Agenda
Village of Arlington Heights
Zoning Board of Appeals
Buechner Room, 1st Floor
Arlington Heights Village Hall, 33 S. Arlington Heights Rd.
November 13, 2023
7:00 PM

**Zoning Board of Appeals
11/13/2023**

Prepared By: Derek Mach, Planner
Hearing Date: November 13, 2023
Date Prepared: November 7, 2023
Project Title: Ahuja Residence
Address: 1220 N. Harvard Ave.

Prepared By: Derek Mach, Planner
Hearing Date: November 13, 2023
Date Prepared: November 8, 2023
Project Title: Malloy Residence
Address: 905 N. Mitchell Ave.

PROPOSED SITE PLAN

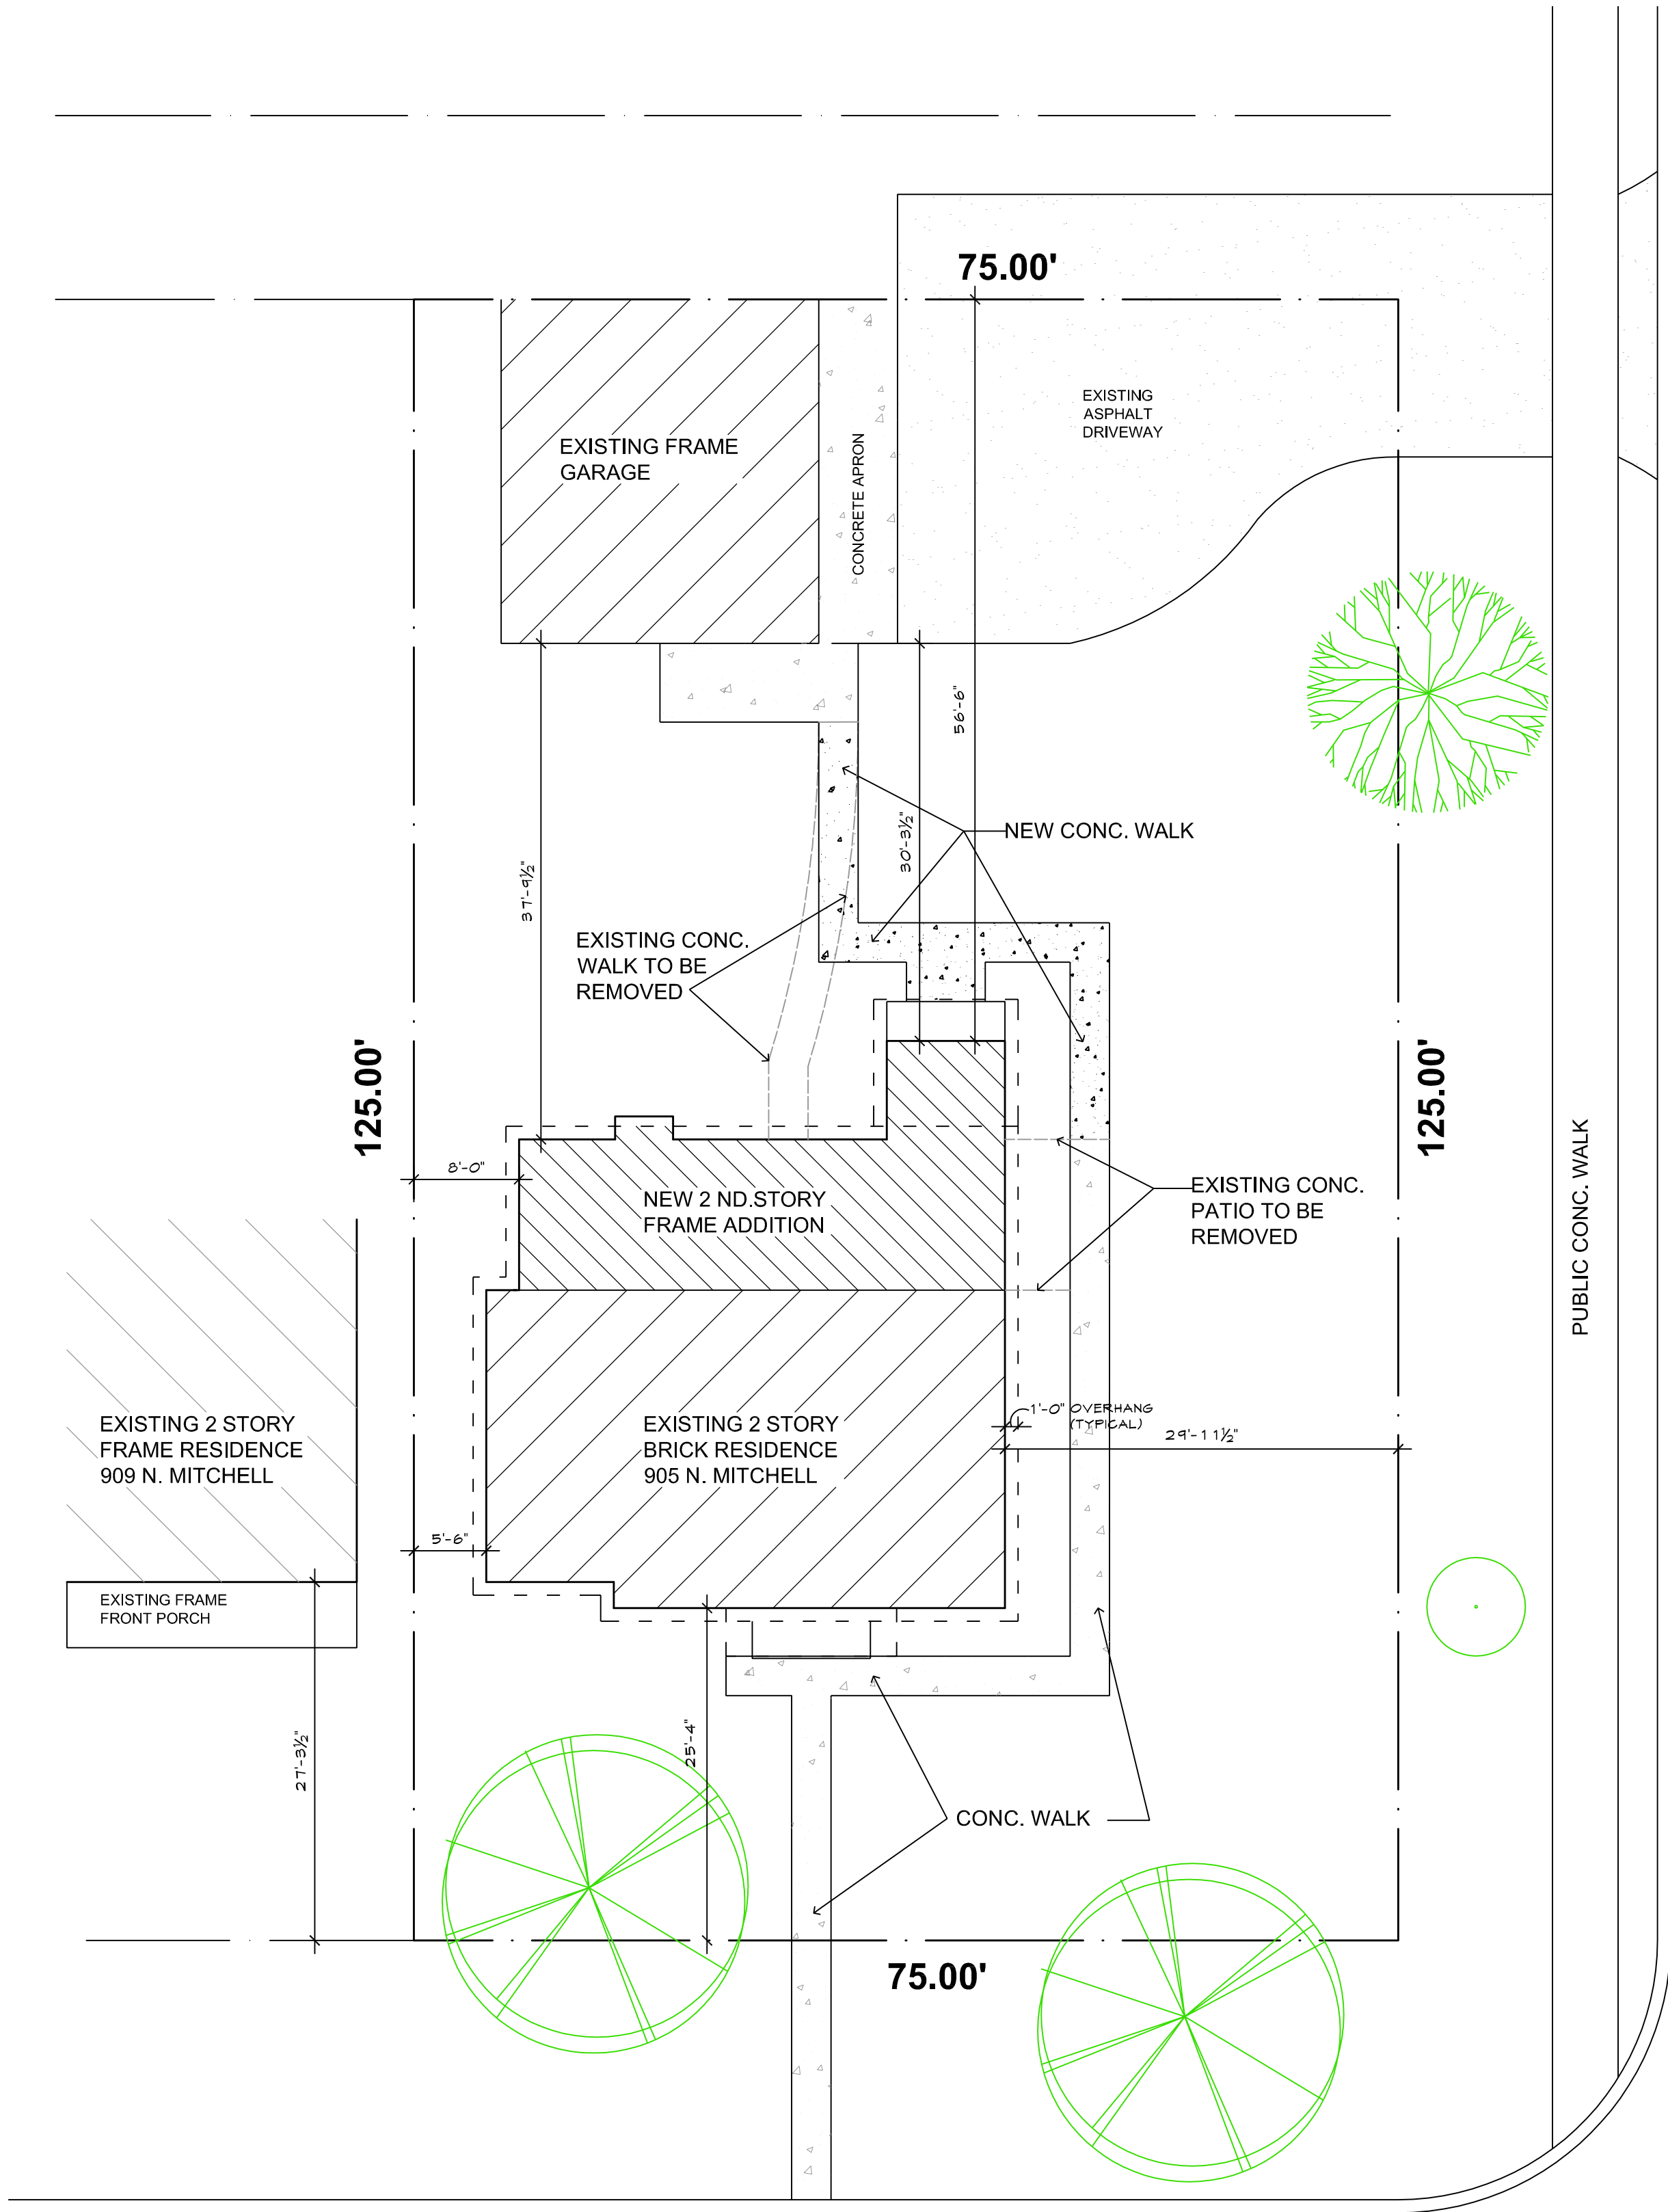
1. The north part of the proposed addition eave soffit within 5 feet of the property line shall have a 1-hour fire-resistance rating or solid blocking between the top plate and the roof sheathing.
2. We have no comment for the second variance on the south side of the proposed addition.
